Document: Addendum No. 1 to Final MND No. 191

Project Name: **Addendum No. 1 to Final Mitigated Negative Declaration No. 191 for Final Closure and Post-Closure Maintenance Plan at Santiago Canyon Landfill for the U.C. Irvine/Ener-Core Landfill Gas Renewable Energy Project**

**OC Waste & Recycling
Log #:** 632

Figure 1: Equipment Layout Adjacent to Existing Flare Station

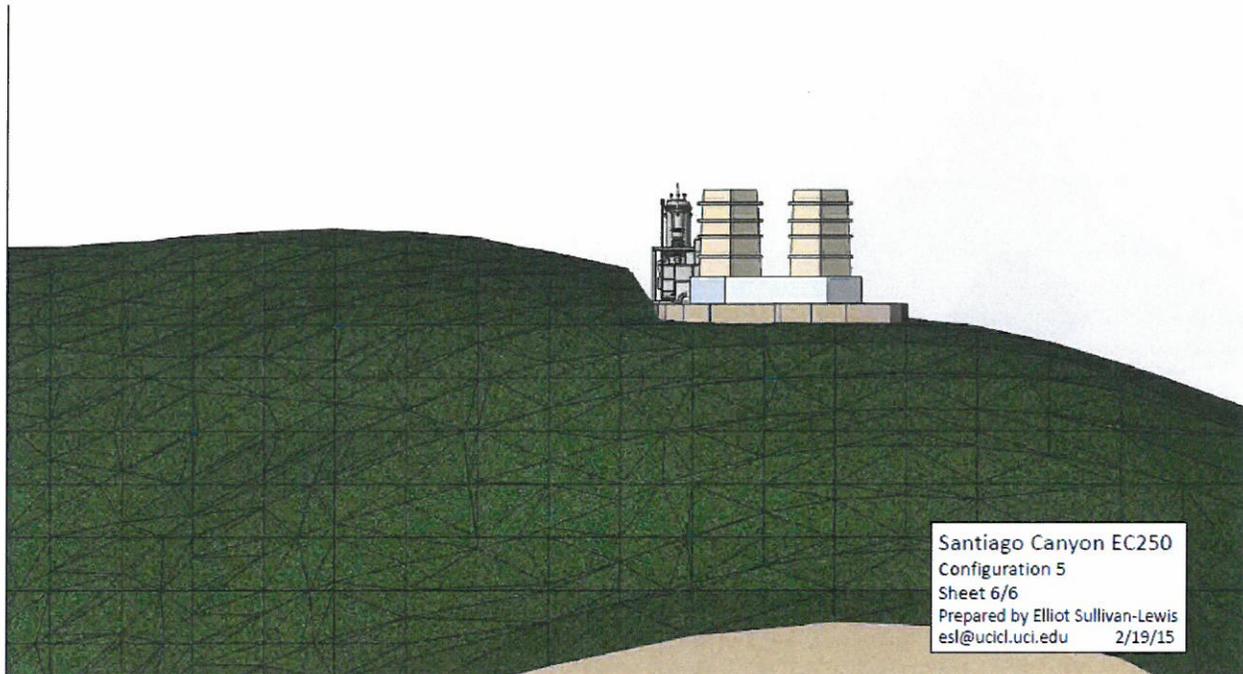
The EC250 will interface with the existing flare station motor control center for the electrical power interconnection. The electric power connection is proposed to be completed through a dedicated generation facility switchboard. Additionally, the EC250 is supplied with a generator braking resistor (“GBR”). The GBR is used to control the EC250 during start-up and shutdown. Figure 1 below shows the equipment layout adjacent to the flare station.

Figure 3: Project Block Diagram

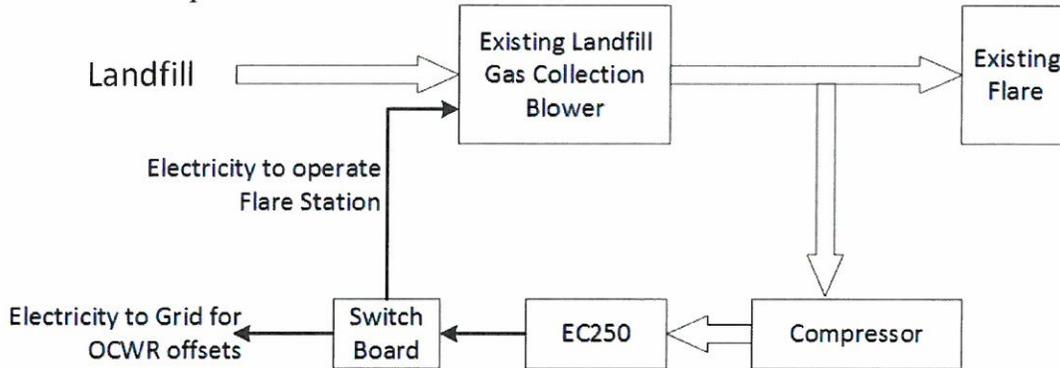
The block diagram (**Figure 3**) below shows the proposed connection points to the flare station gas and electricity. The landfill gas will be compressed and directly injected into the oxidizer for the lowest emissions profile.

Figure 4: EC250 Project Noise Levels vs Distance Away

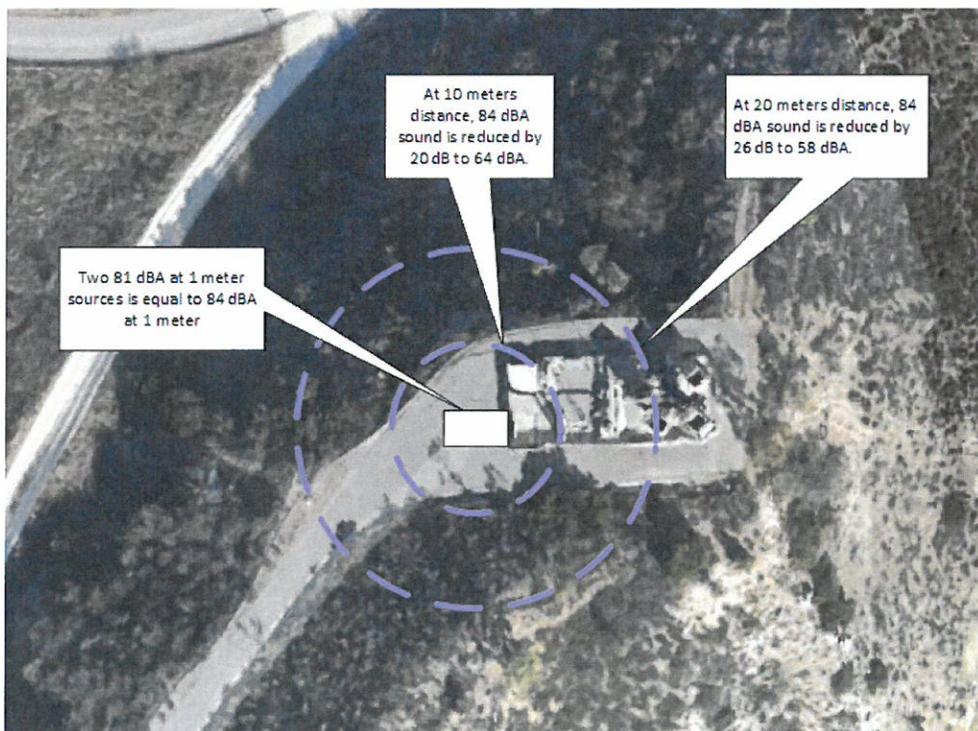
As shown in **Figures 1 and 2**, there are two main sources of continuous sound (noise) from the project: the EC250 and the gas compressor. Each of these systems have noise level ratings of 81 dBA at 1 meter. Combined the two sources will have a noise level of 84 dBA at 1 meter, that is adding a second similar source effectively adds 3 dBA to the noise level. At 10 meters, the noise level drops by 20 dBA to 64 dBA. At 20 meters, the noise level decreases to 58 dBA. **Figure 4** below shows the noise levels relative to the distance away from the EC250 and gas compressor. The proposed project will not result in any significant noise impacts. In addition, there are no sensitive noise receptors located near the project site.
